COUNCIL ASSESSMENT REPORT

Panel Reference	PPSSNH-369
DA Number	MOD0001/23
LGA	Ku-ring-gai
Proposed Development	Modification to Land and Environment Court Consent 391613 of 2018 (DA0197/18) proposing deletion of Condition 17 and amendment to Condition 1
Street Address	1 and 1A Balfour Street, Lindfield (formerly known as 376-384 Pacific Highway, 386-390 Pacific Highway and 1 Balfour Street, Lindfield)
Applicant/Owner	Knight Frank Town Planning / PPI Lindfield Developments Pty Ltd
Date of DA lodgement	31 January 2023
Total number of Submissions Number of Unique Objections	(i) Eighteen received submissions (ii) Thirteen unique submissions
Recommendation	Approval
Regional Development Criteria (Schedule 7 of the SEPP (State and Regional Development) 2011)	A Section 4.56 modification application to a development with a capital investment value of more than \$30 million.
List of all relevant s4.15(1)(a) matters	i. Environmental Planning and Assessment Regulation 2021 ii. State Environmental Planning Policy (Resilience and Hazards) 2021 iii. State Environmental Planning Policy (Transport and Infrastructure) 2021 iv. Ku-ring-gai Local Environmental Plan, 2015 (KLEP) v. Ku-ring-gai Developm

Option 1: Access via Bent Lane

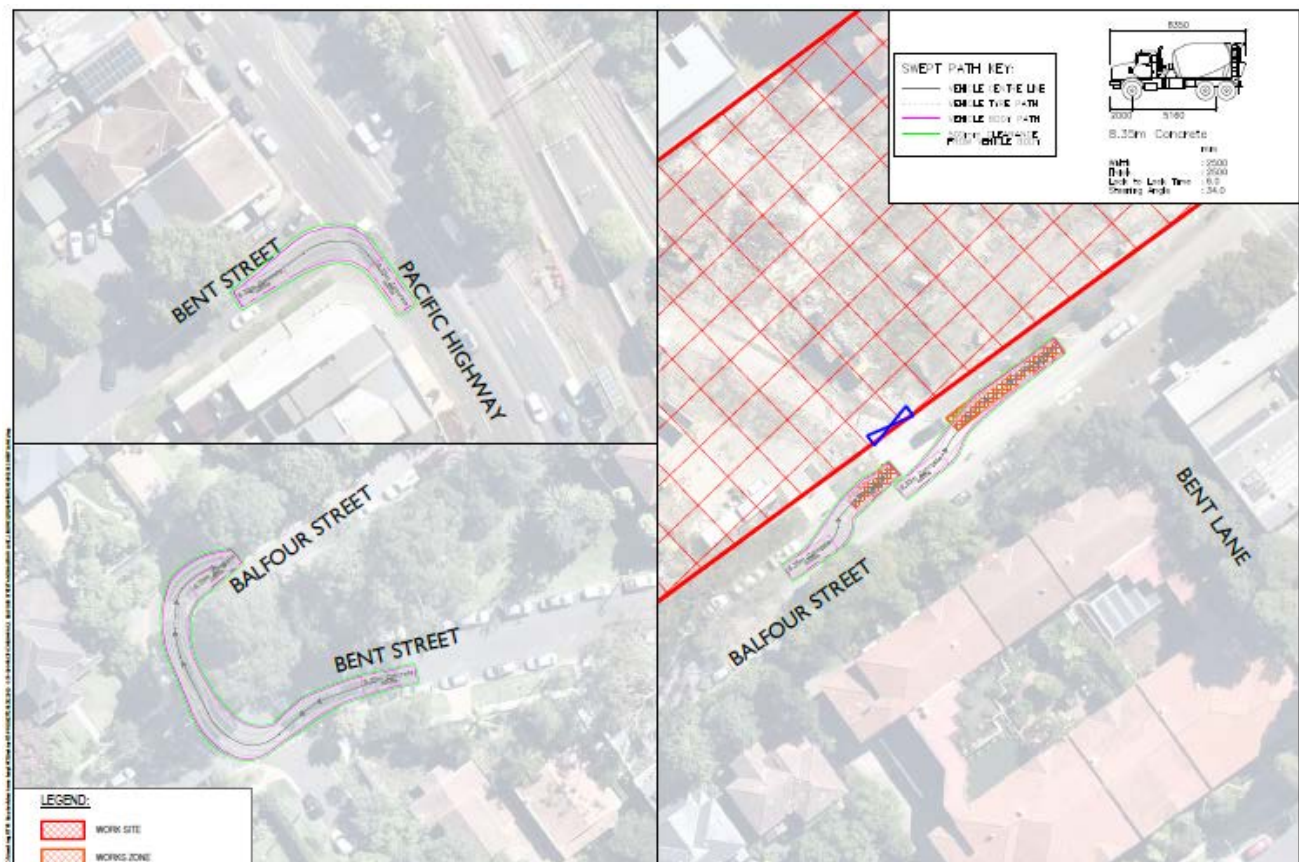
- *Two (2) alternate routes are proposed for concrete trucks to enter and exit the works zone (**Option 1** and **Option 2**). In summary, concrete trucks will arrive on-site via Bent Street and utilise either Bent Lane or Balfour Street to gain access into the works zone. These alternate routes do not require access to Balfour Lane. Therefore, in accordance with the amended CTMP, concrete truck movements for the critical stages only will not utilise Balfour Lane and safety concerns in relation to school attendants and pedestrian safety associated to Highfields Preparatory and Kindergarten School and Holy Family Catholic School are mitigated.*

Council prefers Option 2, which requires concrete truck movements for the critical stage pours only, to travel along Pacific Highway in a northerly direction, then turning left onto Bent Street, then right onto Balfour Street and to travel in an easterly direction along Balfour Street to access the approved Work zone. Council raised concerns with Option 1, due to the possible queuing as a result of the trucks reversing into the Work Zone if trucks were to utilise Bent Lane.

clearly differentiate the proposed modifications relate only to concrete truck movements for critical stage structural pours only and ongoing construction vehicle movements reverts back to standard restrictions. Recommended modified **Condition 17** is as follows (**amendments noted in bold italics**):
